FILE P.I. # 0006684
CSMSL-0006-00(684)
Fulton County
GDOT District 7 - Metro Atlanta
SR 141/Peachtree Road LCI - from
Shadowlawn Avenue to Maple Drive

SUBJECT APPROVED REVISED CONCEPT REPORT

**DEPARTMENT OF TRANSPORTATION
STATE OF GEORGIA
REVISED PROJECT CONCEPT REPORT**

Revised concept for Peachtree Corridor Complete Street Retrofit – Phase 3 from Shadowlawn Avenue to Maple Drive to incorporate revised typical sections for lane widths and shoulder dimensions.

ATTACHMENT #1
 PEACHTREE ROAD CORRIDOR IMPROVEMENTS
 DESIGN VARIANCE REQUEST
 MEDIAN SPACING

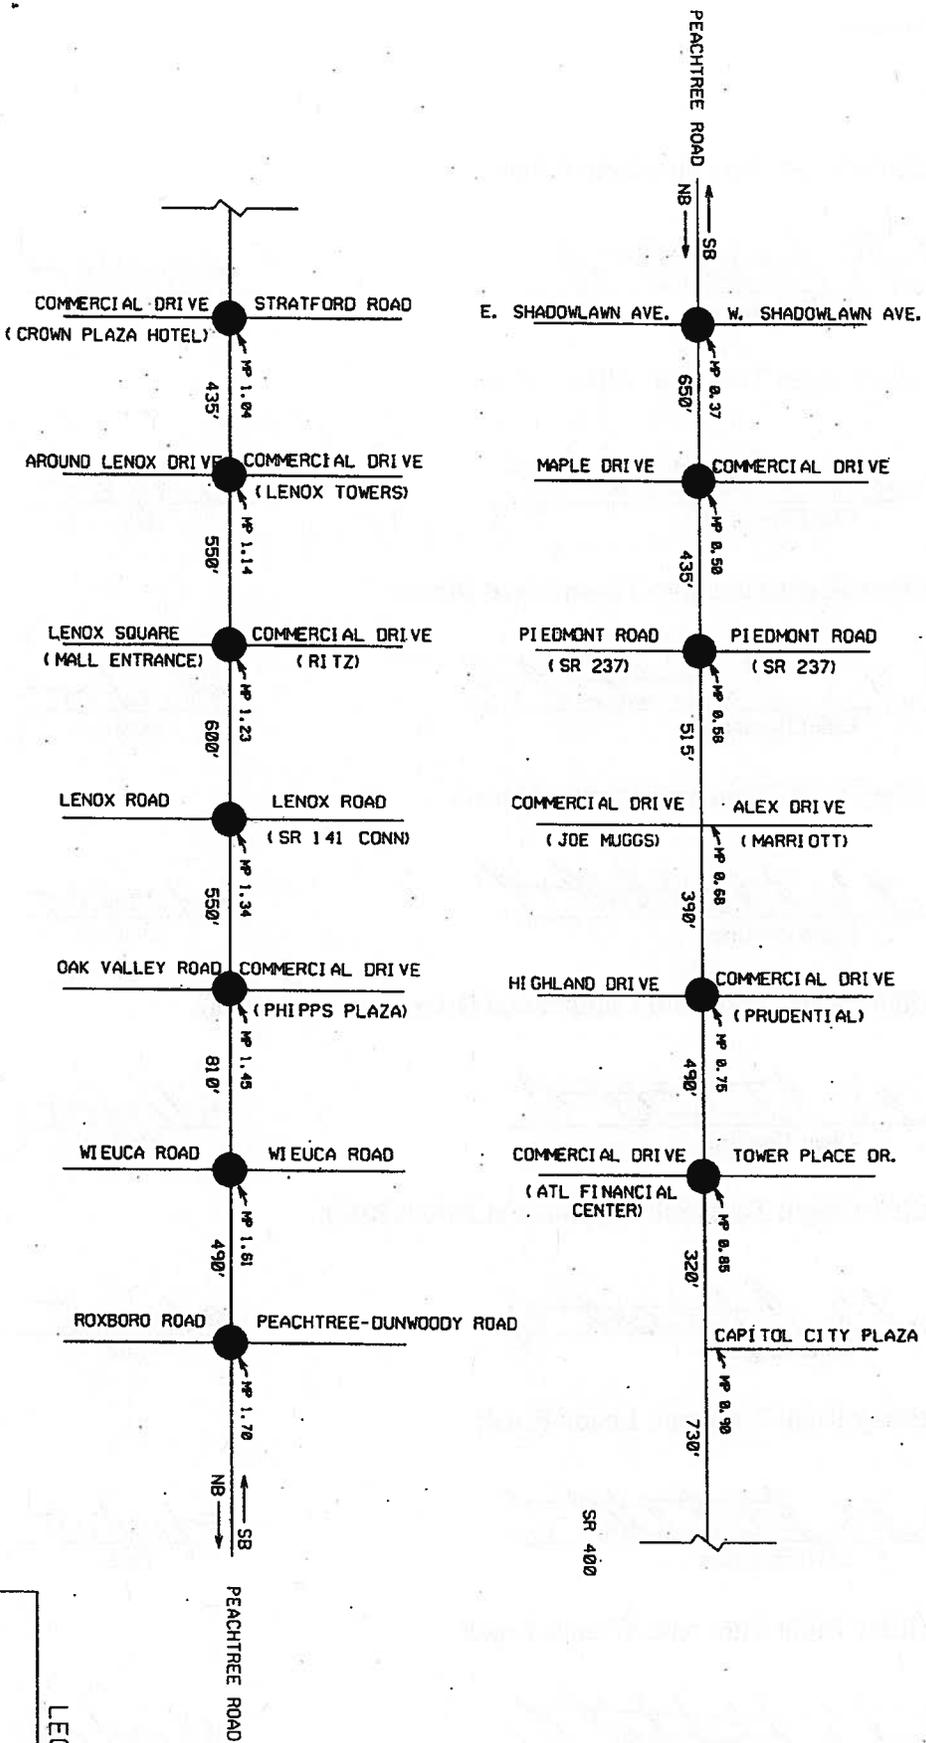
The Department's guidance for median opening spacing is found in the Regulations for Driveway and Encroachment Control manual and states that the spacing for an urban non-signalized condition is 1320-ft desirable and 660-ft minimum. The spacing for an urban signalized condition is 1000-ft desirable and 660-ft minimum. It is proposed to provide median openings at the existing signalized intersection locations as well as the two non-signalized critical access points (see attachment 1 for location and spacing). The first access point is a SB left-in only commercial drive which serves the commercial establishment, Joe Muggs (mp 0.68). The second access point is a NB left-in only located at the entrance to Capitol City Plaza (mp 0.90). A design variance is requested for substandard median spacing at each signalized and non-signalized condition within the Peachtree Road project limits except for the signalized conditions at SR237/ Piedmont Road and SR141 CONN/ Lenox Road. See below for a description of each condition.

Spacing cannot be met because of negative impacts to traffic operations and limitations of access to existing commercial and residential development. Maple Drive is an existing signalized intersection. If the median opening was eliminated, the opening year peak hour of 400 vehicles would be shifted to adjacent intersections. The NB peak hour left-turn volume of 120 vehicles would be expected to shift to the upstream intersection at Piedmont Road. Since U-turns are not allowed at Piedmont Road due to overlap signal phasing, these vehicles would be required to

- Lane widths of 10-ft and 11-ft along Peachtree Road.
- Median opening at Maple Drive/ Commercial Drive.
- Median opening at the Commercial Drive (Joe Muggs) – SB left-in only.
